SUBJECT: Application for amends to licenses DPR-38, DPR-47 & DPR-55, addressing USQ re NPSH requirements for RBS pumps during post-accident recirculation phase. Marked-up UFSAR pages, reflecting results of NPSH analysis, encl.

SUBJECT: Duke Energy Corporation  
Docket No(s). 50-269, -270, -287  
Oconee Nuclear Station Units 1, 2, and 3  
Proposed Amendment to the Facility Operating  
License Regarding Reactor Building Overpressure to  
Assure Net Positive Suction Head for the Reactor  
Building Spray Pumps

Attachment 1

### Description and Justification of the Proposed Changes to the Oconee Updated Final Safety Analysis Report

FIGURE 1

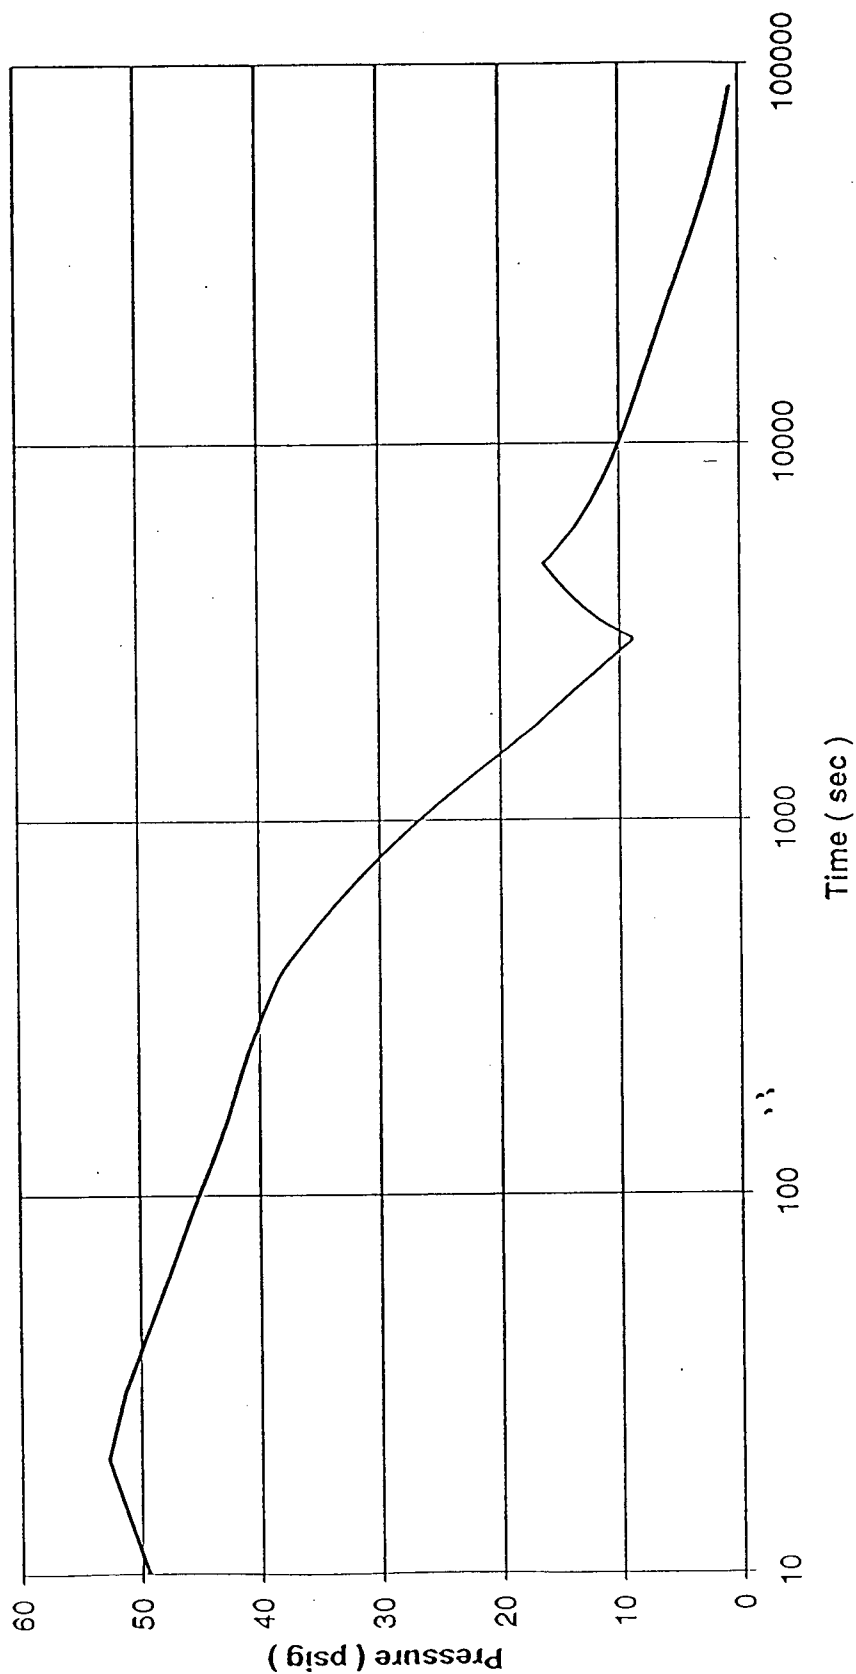
The building pressure, vapor temperature, and sump temperature responses as a function of time are shown in Figures 1, 2, and 3 as a representative case which reflect the above assumptions. Additional cases were run varying the RBCU capacity between 60 E6 Btu/hr and 160 E6 Btu/hr. These cases show the same general trends as illustrated in these figures and are not represented here. In each figure, the start of sump recirculation mode is visible, as containment cooling decreases at this point. Figure 4 provides a conservative overlay of building pressure versus sump temperature for the spectrum of cases analyzed.

FIGURE 3

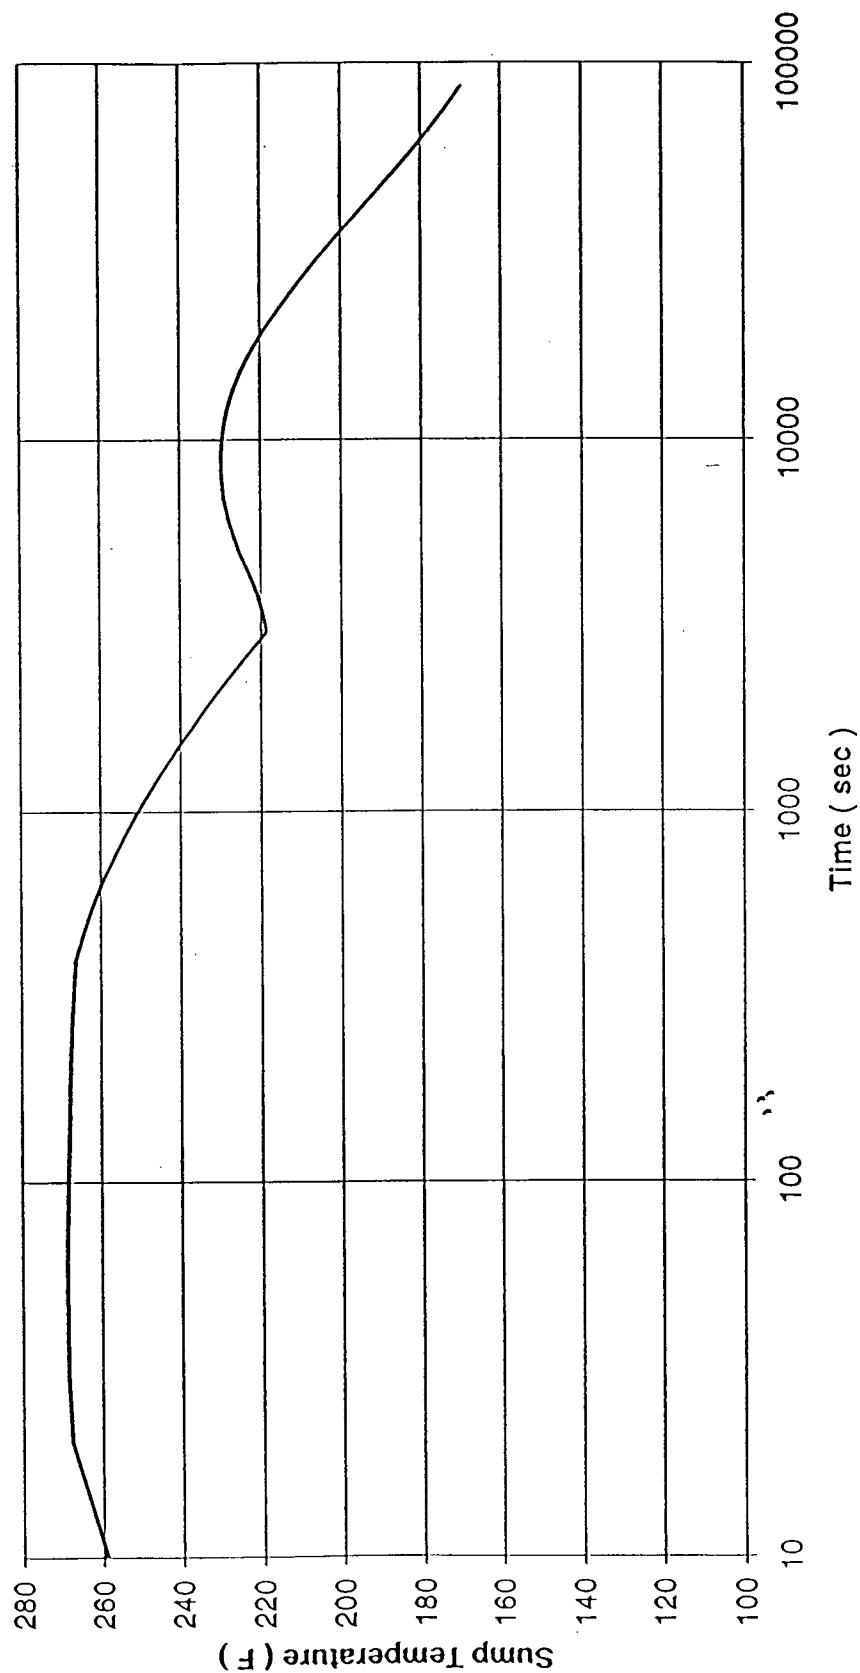
Reactor building overpressure is required to be credited from approximately 3000 seconds (i.e., the time that pump suction is transferred to the sump) to approximately 27,000 seconds (i.e., the time the sump temperature drops below 210°F) following the onset of the LOCA. Figure 3 of Attachment 2 provides a graph of sump temperature versus time.

FIGURE 4

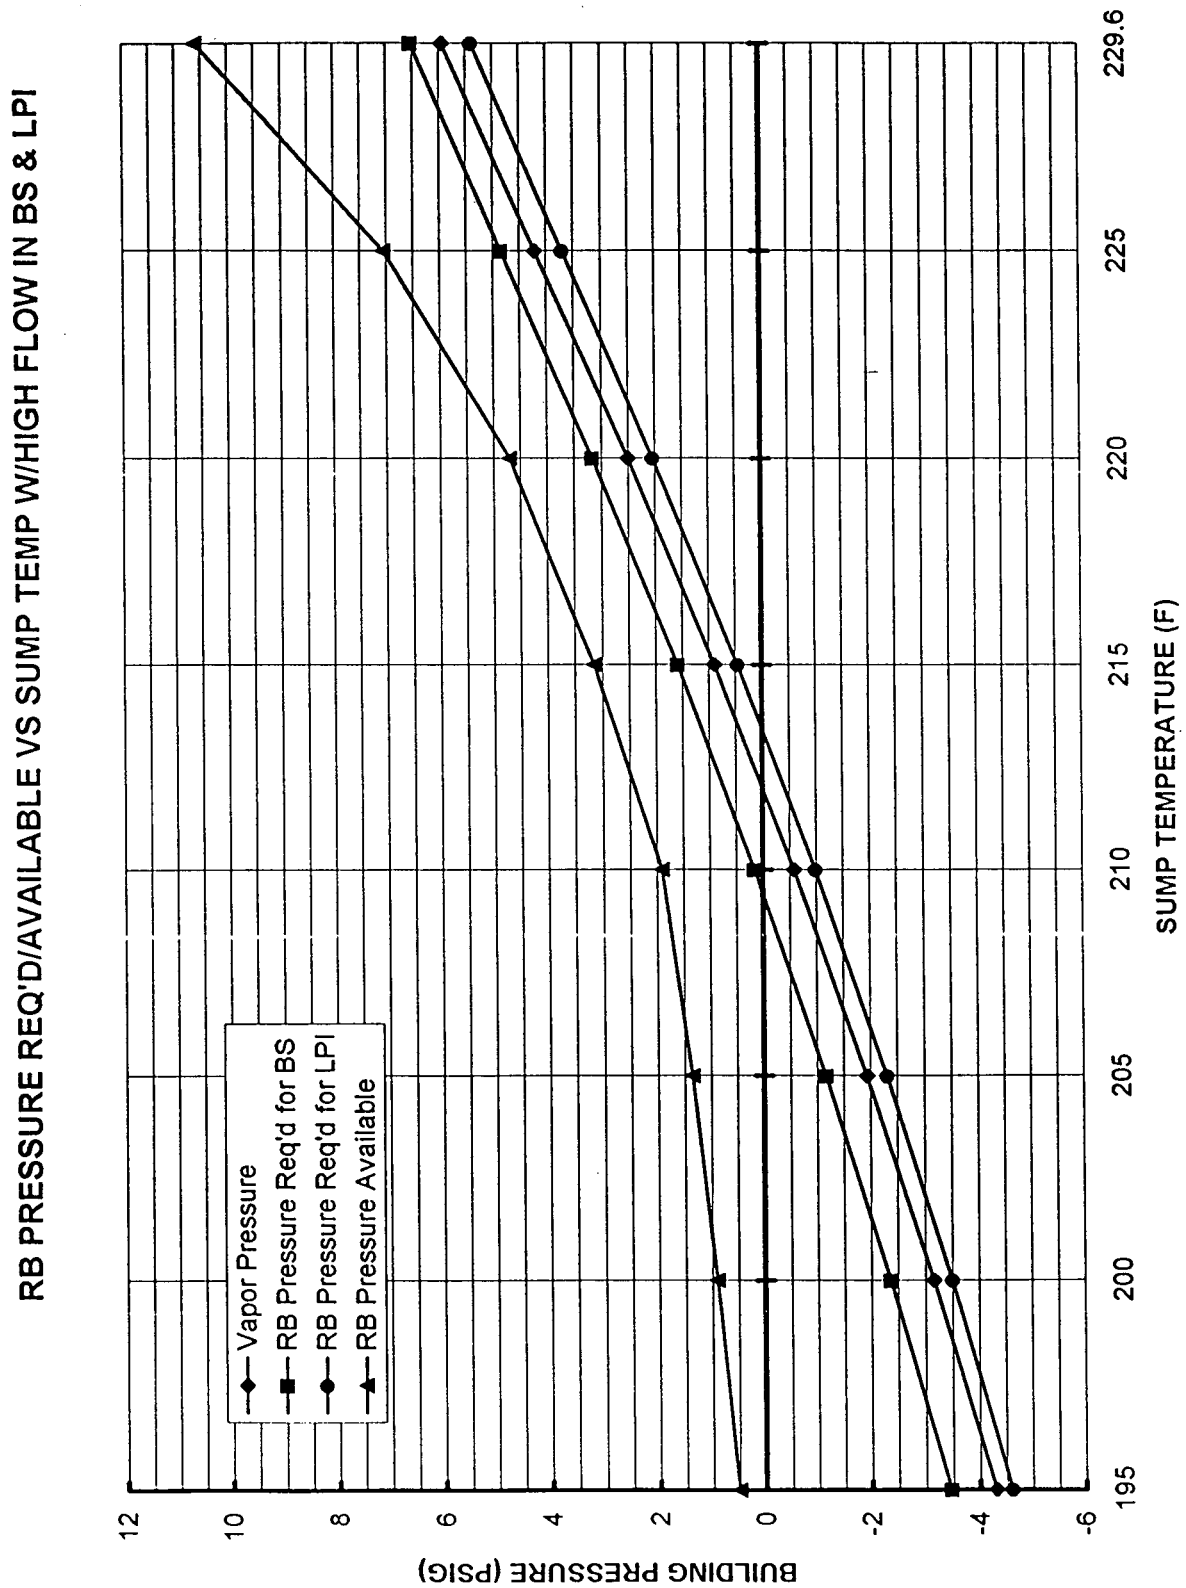
In all cases, the NPSH analysis showed that the available NPSH exceeded the required NPSH for all sump temperatures for the RBS pumps. A visual representation of this conclusion is provided in Figure 4.
